**Review of Revised Architecture and Building Materials  
Montgomery Quarter - Phase 3 - Apartments**

**September 25, 2020**

# MONTGOMERY QUARTER- PHASE 3

## LANDMARKS COMMISSION FINAL SUBMISSION

# BUILDING L ELEVATIONS

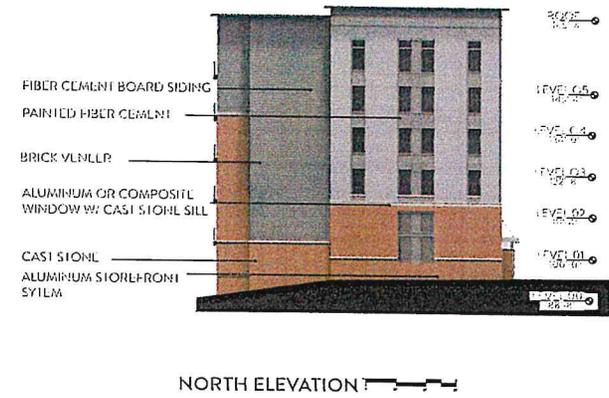
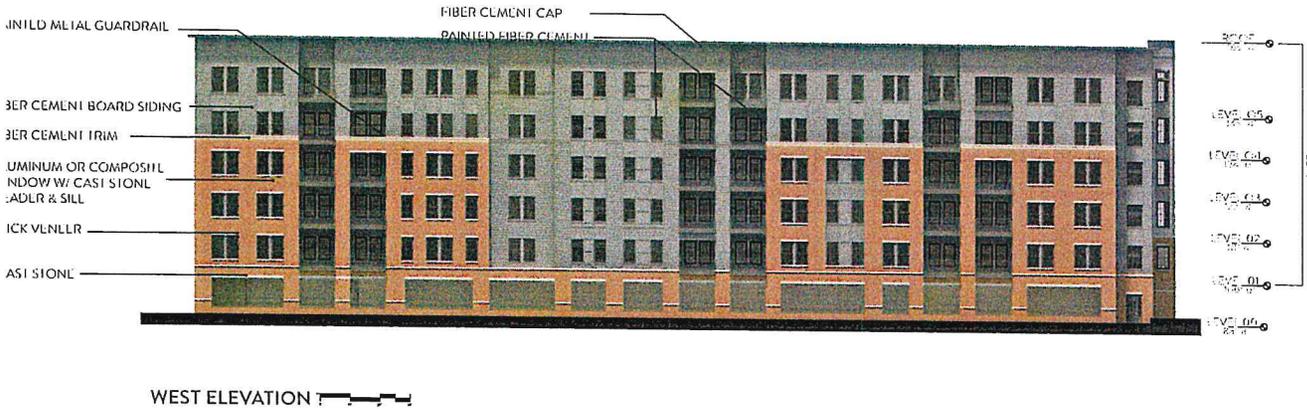
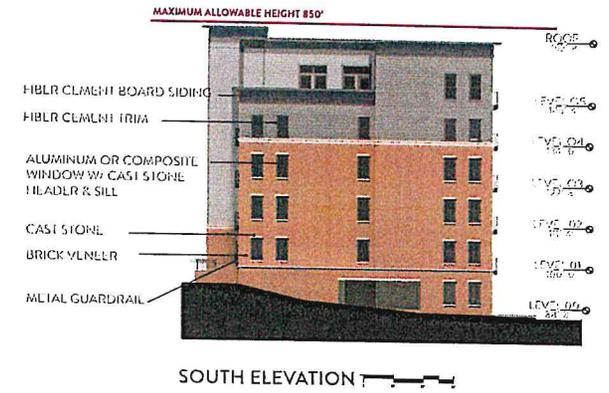
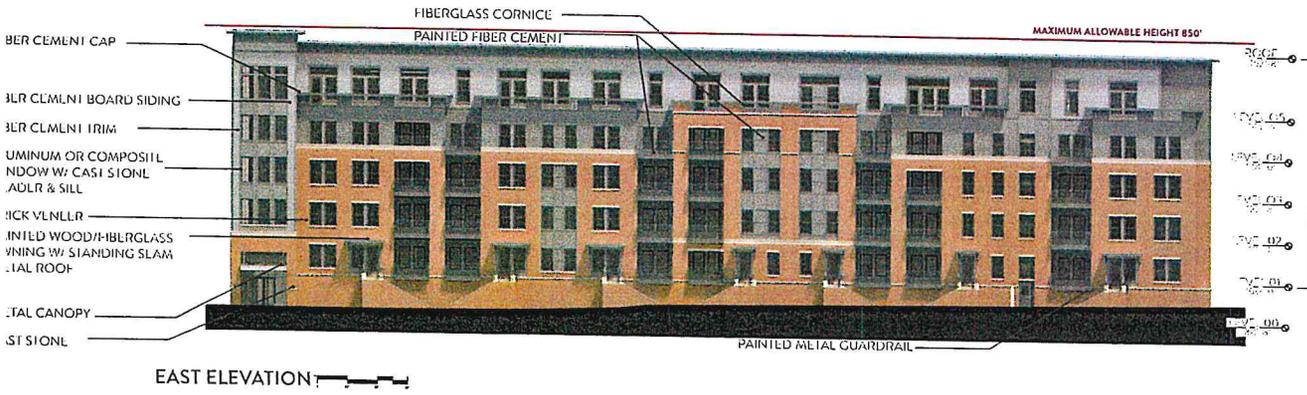
The overall height of Buildings L and K has increased due to the addition of another level; however, the overall architectural design remains similar to the previous

The design team has also incorporated an additional lighter gray color for the fiber cement on the top floor and added railings and which helps lighten the building and keeps the top floor from feeling heavy. The horizontal massing of the buildings is broken up with the use of setback variations, recesses, balconies, staircases and variation in materials.

The building materials for Buildings L and K remain the same with a change in the color of the fiber cement board. The applicant is proposing to use Brick Bowerston Sante Fe Wire Cut for the brick, which is what was previously proposed. The fiber cement board is now proposed to be in two colors, Sherwin Williams 7059 Unusual Gray and Sherwin Williams 7057 Silver Strand. Staff believes that the lighter gray siding and the use of two different colors helps soften the overall look of the buildings and breaks up the massing.

# BUILDING I ELEVATIONS

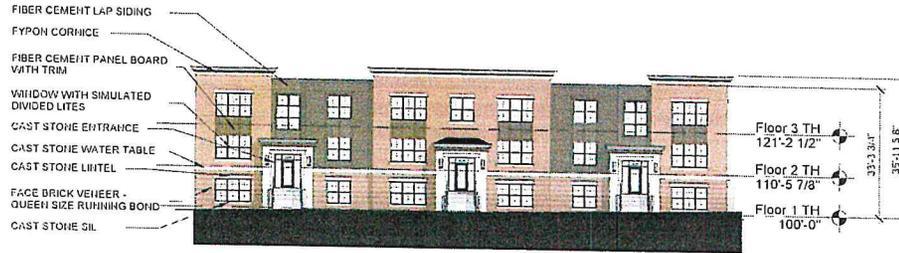
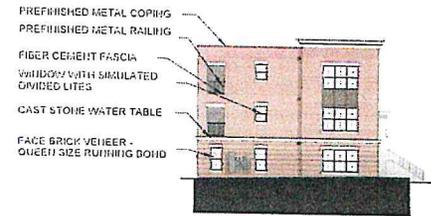
There are two changes to the project since the Landmarks Commission reviewed the architecture of the buildings in April. The first change is the height of buildings I and J. Both buildings were proposed at a height of 50.5' with a roof deck. This proposed height was in compliance with the Zoning Code for Building I as the Zoning Code would allow the building to a maximum of 60' in height or an elevation of 850; however, due to the proximity to the Heritage District Building J is not permitted to exceed 40' in height. Therefore, the proposed building height for Building J was 10.5'

The architecture of Buildings I and J is significantly different than what was reviewed previously by the Landmarks Commission in that the buildings are smaller scale and of a more traditional design. During the previous submittal, Staff had some concerns that the architecture was a bit too modern for the proximity to the Heritage District. Staff believes that the redesign of these buildings with a smaller scale and more traditional design elements, such as walk-ups and a traditional cornice is a better fit for the proximity to the Heritage District and Landmark homes. The design team has also done a very nice job utilizing setback variances and variations in materials to break up the horizontal massing to give the building verticality, establish a human scale and provide visual rhythm and interest.

While the design of Buildings I and J have changed, the primary building materials and colors remain the same as the original submission. The elevations show the use of brick and fiber cement board as the primary building materials with cast stone headers and sills. The applicant is proposing to use Glen Gary Canyon blend for the brick and Sherwin Williams 7020 Black Fox for the fiber cement board. The cast stone is proposed to be Rockfast Charlotte Tan and the cornice is Sherwin Williams Mindful Grey.
